Re: Betos Boots
5901 Rio Vista Dr., SW
Traffic Circulation Layout
Engineer's/Architect's Stamp **5-17-16** (L11-D068)

Based upon the information provided in your submittal received 5-26-16, the above referenced plan cannot be approved for Building Permit until the following comments are addressed:

Traffic Circulation

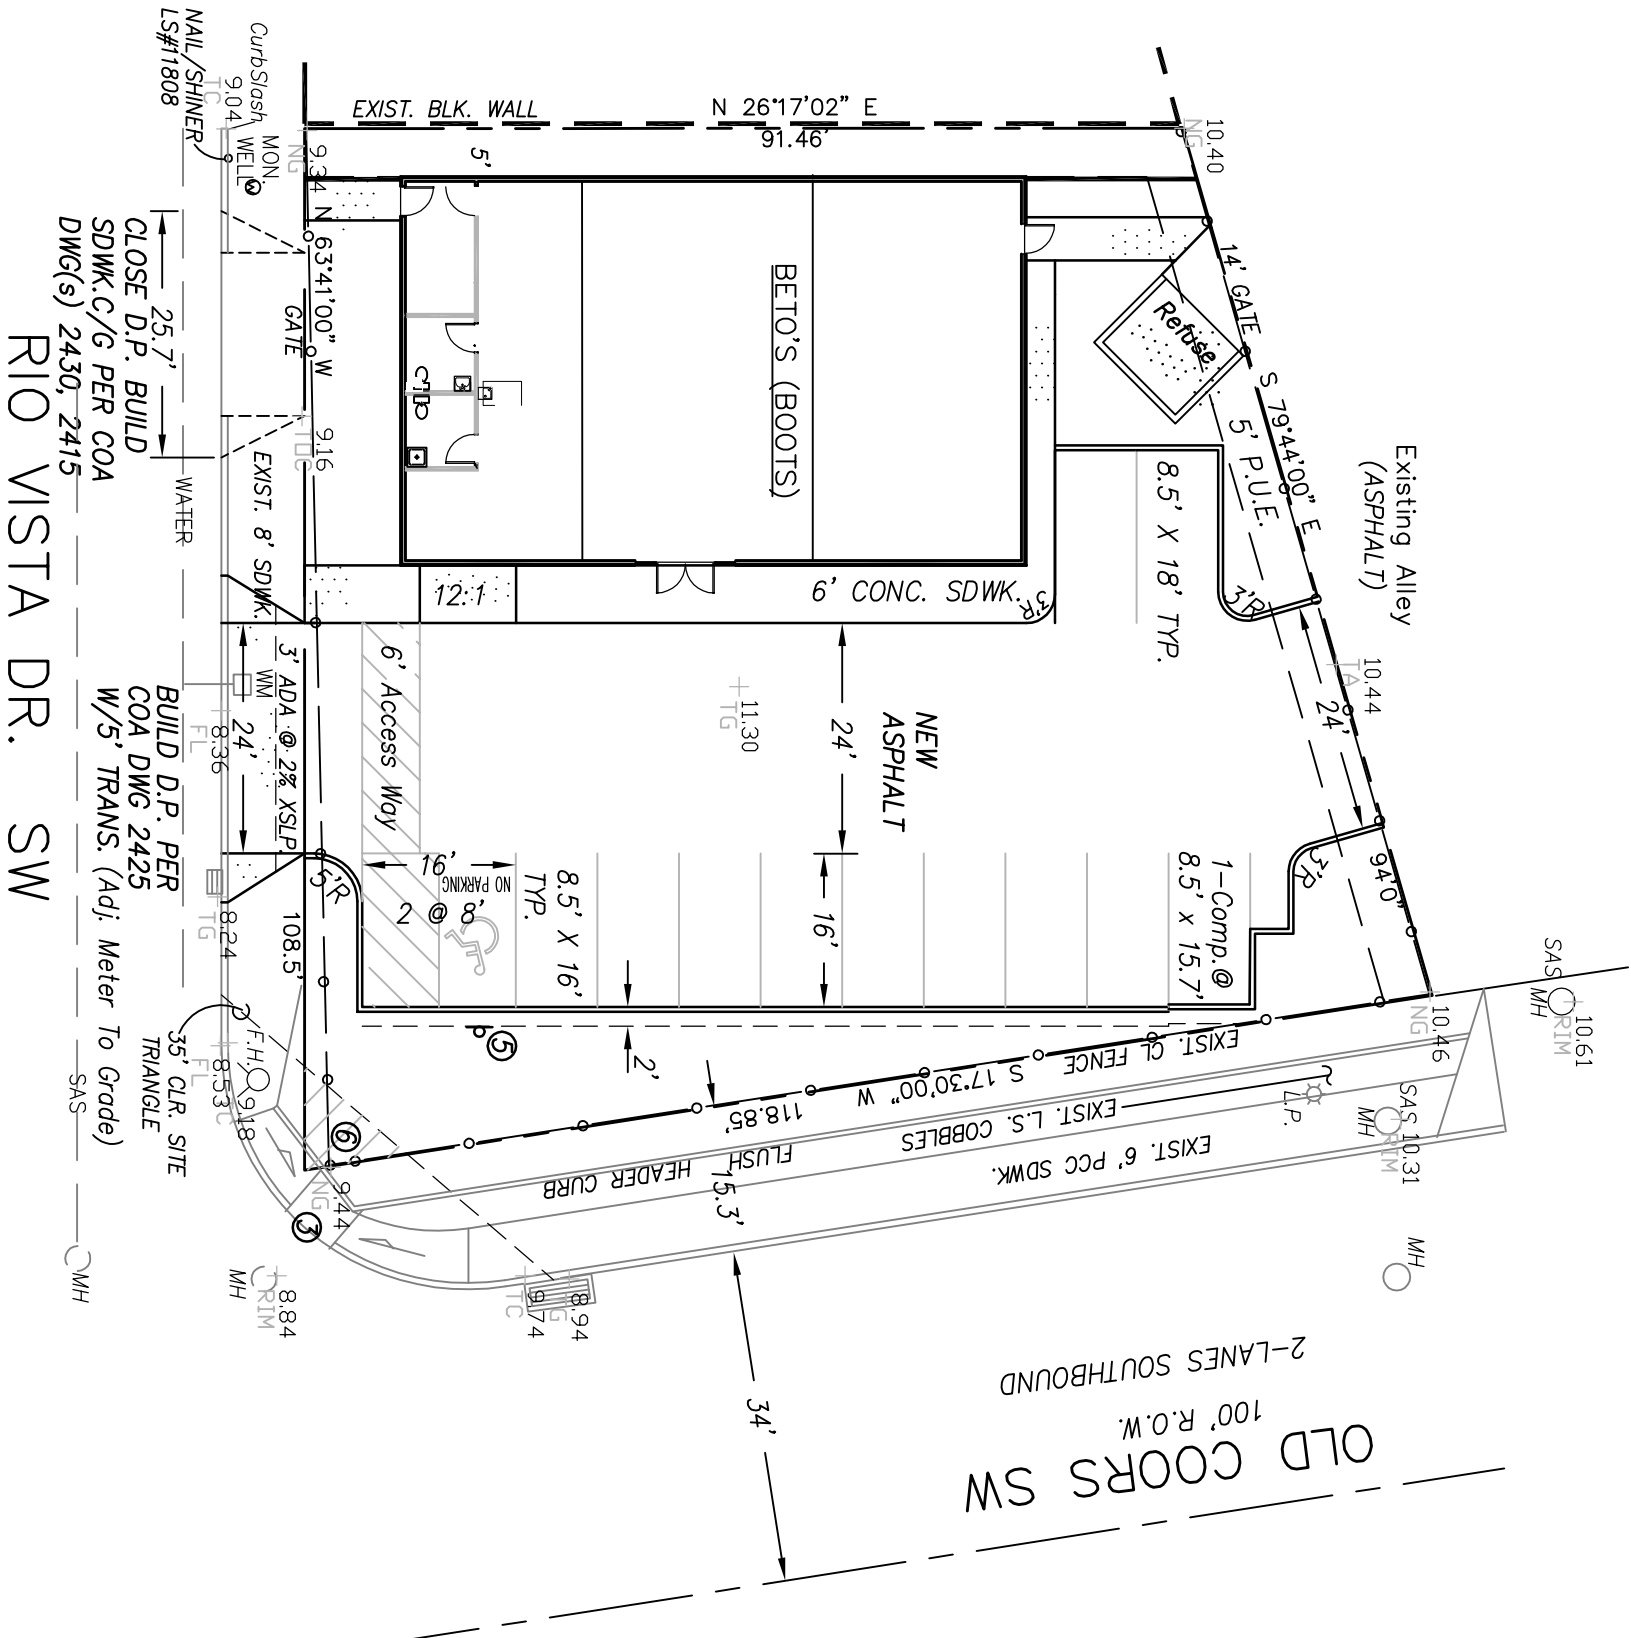
1. Identify all existing access easements and rights of way width dimensions.
2. Identify the right of way width, medians, curb cuts, and street widths on Rio Vista Dr.

3. The ADA access aisles shall have the words **"NO PARKING"** in capital letters, each of which shall be at least one foot high and at least two inches wide, placed at the rear of the parking space so as to be close to where an adjacent vehicle's rear tire would be placed. (66-1-4.1.B NMSA 1978)

4. Per DPM, a 6 ft. wide ADA accessible pedestrian pathway is required from the HC parking stall access aisles to the building entrances. It is preferable that the ADA pathway does not cross the drive pad. Please review if HC parking can be placed at the north west parking spaces.

5. Provide a min 6" or max 8" high concrete barrier curb or other acceptable barrier between landscaping and parking areas and/or drive aisles. Please call out detail and location of barrier curb.

6. Service vehicle and/or refuse vehicle maneuvering must be contained on-site; provide a copy of refuse approval.
7. Please provide a sight distance exhibit (see the *Development Process Manual, Chapter 23, Section 3*). Please show this detail for the entrance/exit off of Rio Vista Dr. and the public alley.

8. All broken or cracked sidewalk must be replaced with sidewalk and curb & gutter. A build note must be provided referring to the appropriate City Standard drawing.
